CRYSTAL RIVER UNIT 3 NUCLEAR GENERATING PLANT

AMENDMENT TO FACILITY OPERATING LICENSE

Amendment No. 25
License No. DPR-72

ATTACHMENT TO LICENSE AMENDMENT NO. 25

Figure 6.2-1 Offsite Organization

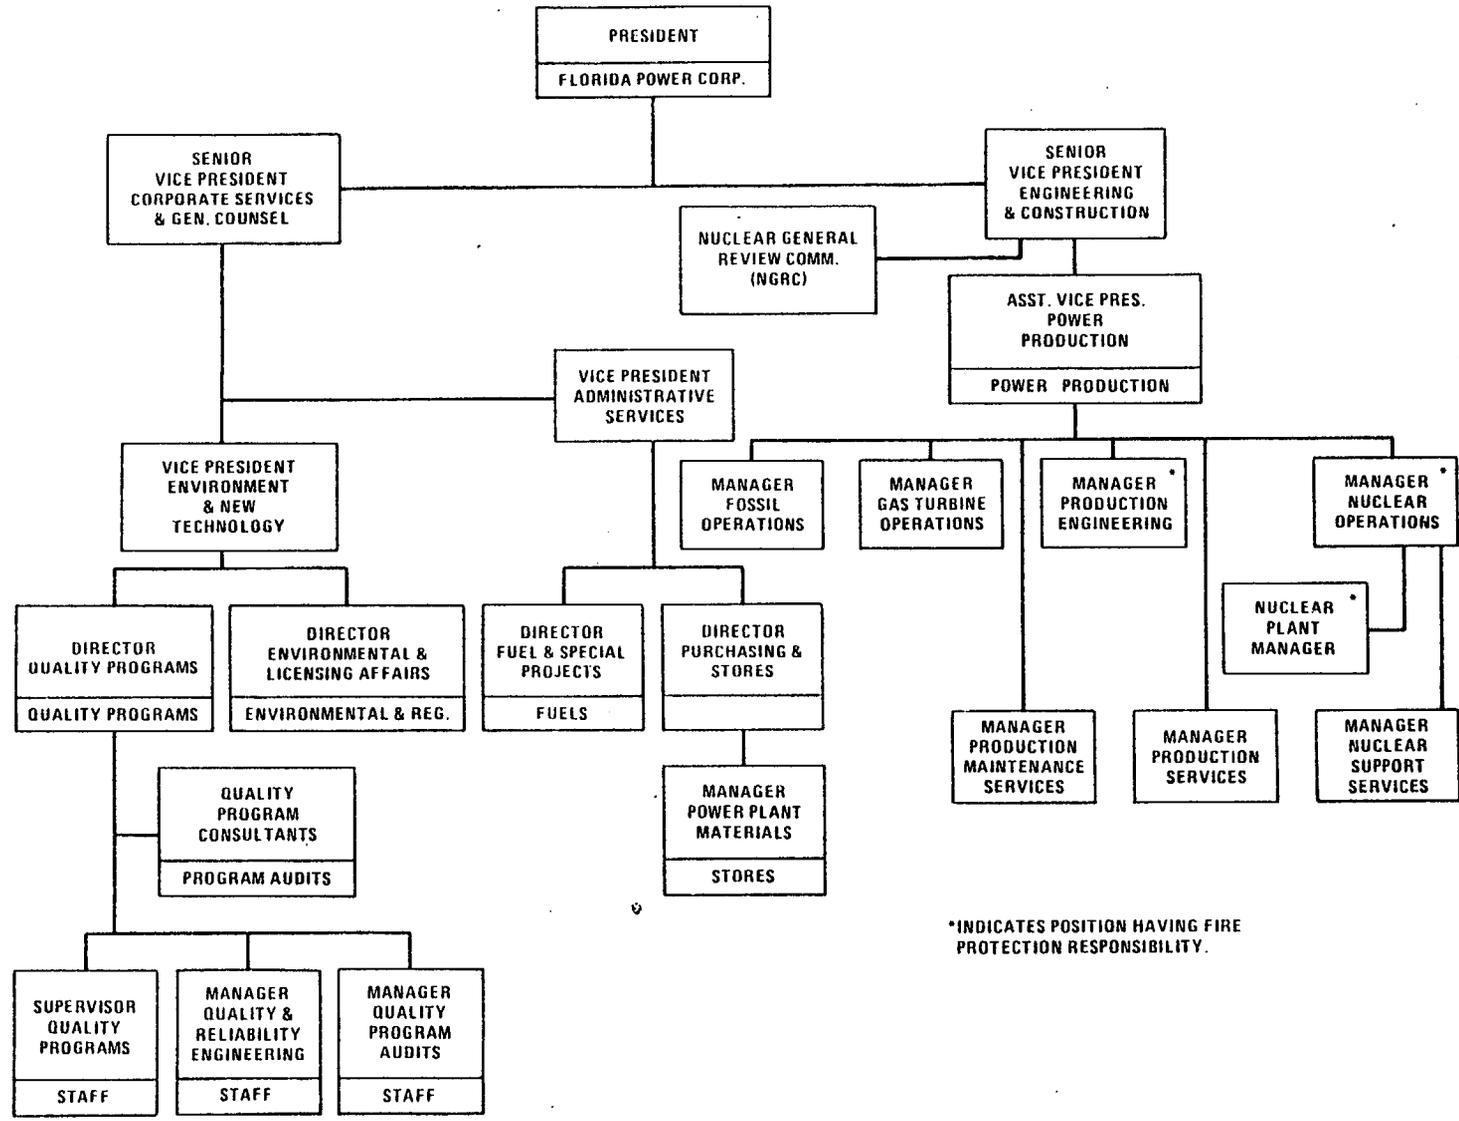
6.2.1 The offsite organization for facility management and technical support shall be as shown on Figure 6.2-1.

The revised offsite organization will establish a management position at the corporate offices of FPC which deals solely with operation of nuclear plants. This position is the Manager-Nuclear Operations. Previously the Nuclear Plant Manager and the Manager-Nuclear Support Services reported to the Director-Power Production whose office was also responsible for non-nuclear related power production operations. In the modified organization, the Nuclear Plant Manager and the Manager-Nuclear Support Services report to the Manager-Nuclear Operations.

The revised offsite organization should enhance corporate level management attention to the operation of CR-3 and is acceptable.

FIGURE 5.1-1 ORGANIZATION FOR IMPLEMENTING ENVIRONMENTAL TECHNICAL SPECIFICATIONS .

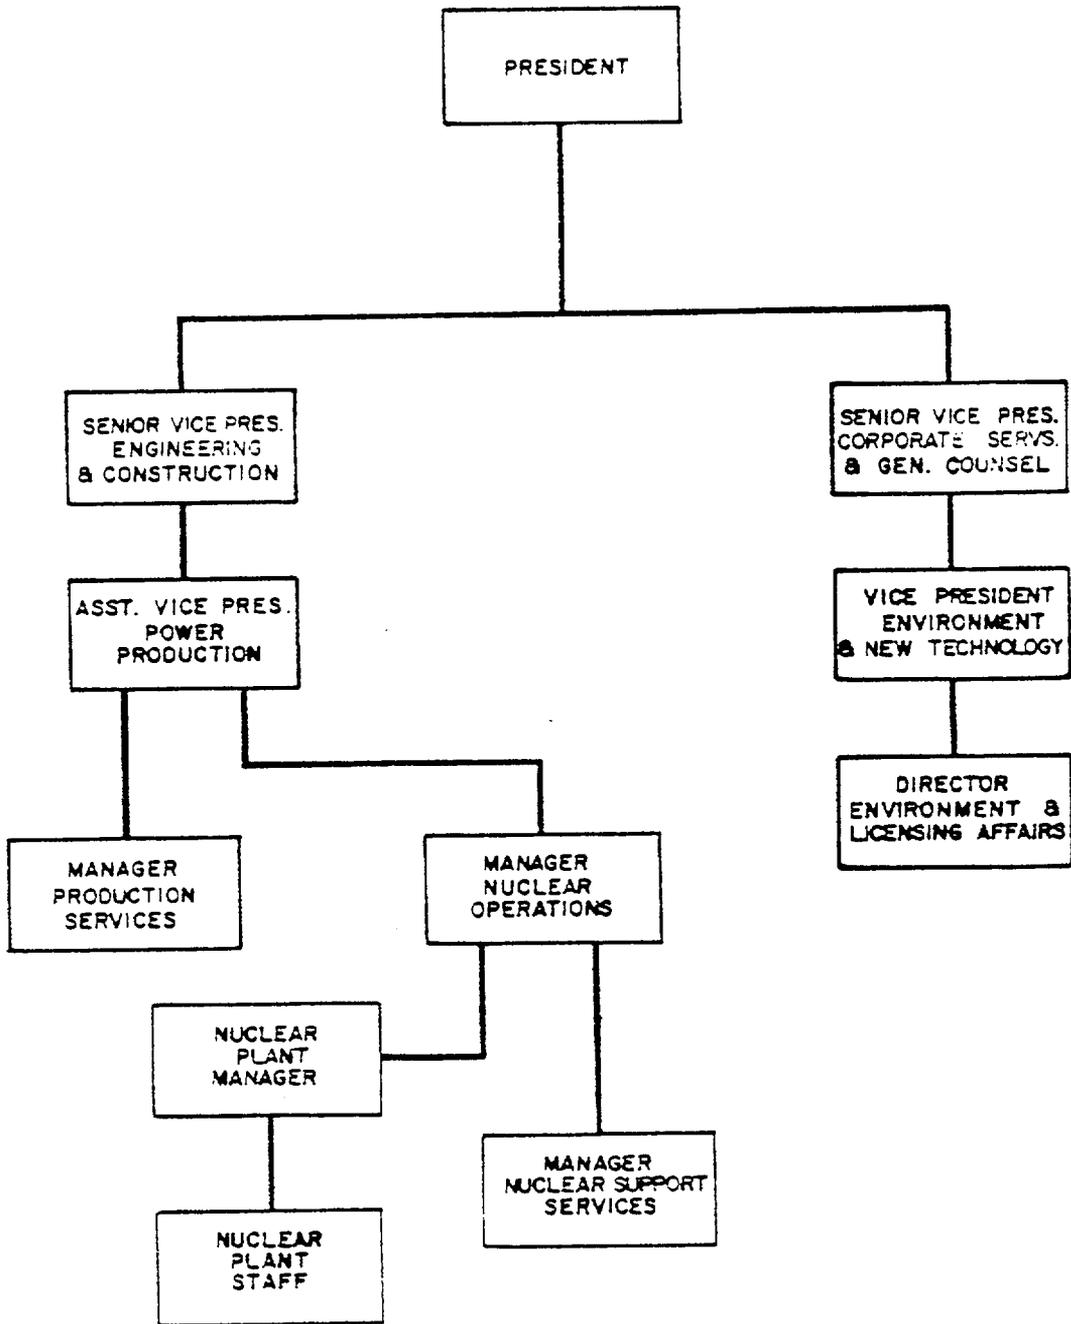
The organization responsible for environmental protection, environmental monitoring and the implementation of the Environmental Technical Specifications for Crystal River Unit 3, is shown on Figure 5.1-1.

By letter dated July 21, 1977, the licensee proposed a change to the format of the Environmental TS to more clearly define the functions and responsibilities of the Nuclear General Review Committee in environmental matters. This change clarifies the Environmental TS and is acceptable.

FIG. 5.3-1 ORGANIZATION FOR INDEPENDENT REVIEW AND AUDIT.

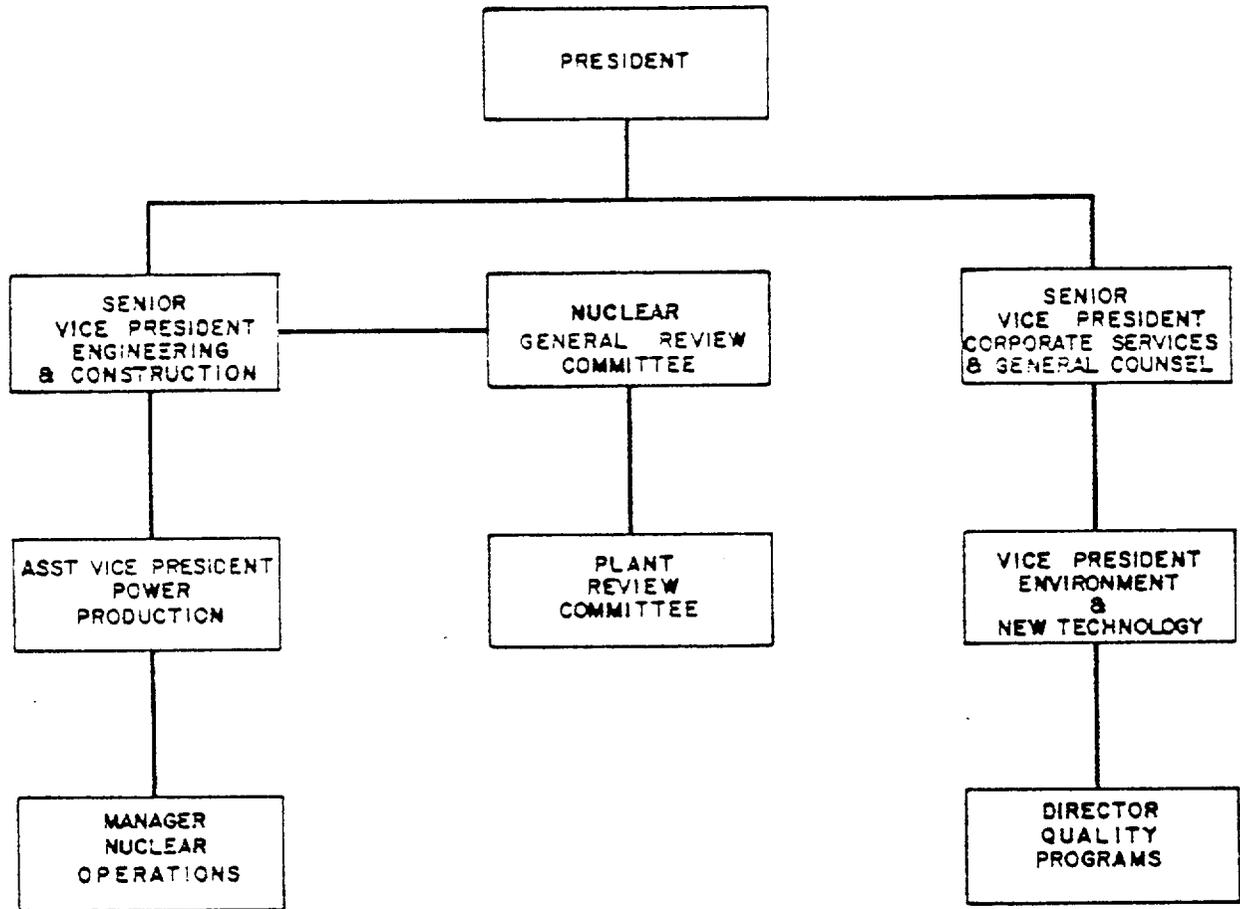
The NGRC shall report to and advise the Senior Vice President Engineering and Construction on those areas of responsibility specified in Sections 5.3.8, 5.3.9 and 5.3.10 (see Figure 5.3-1).
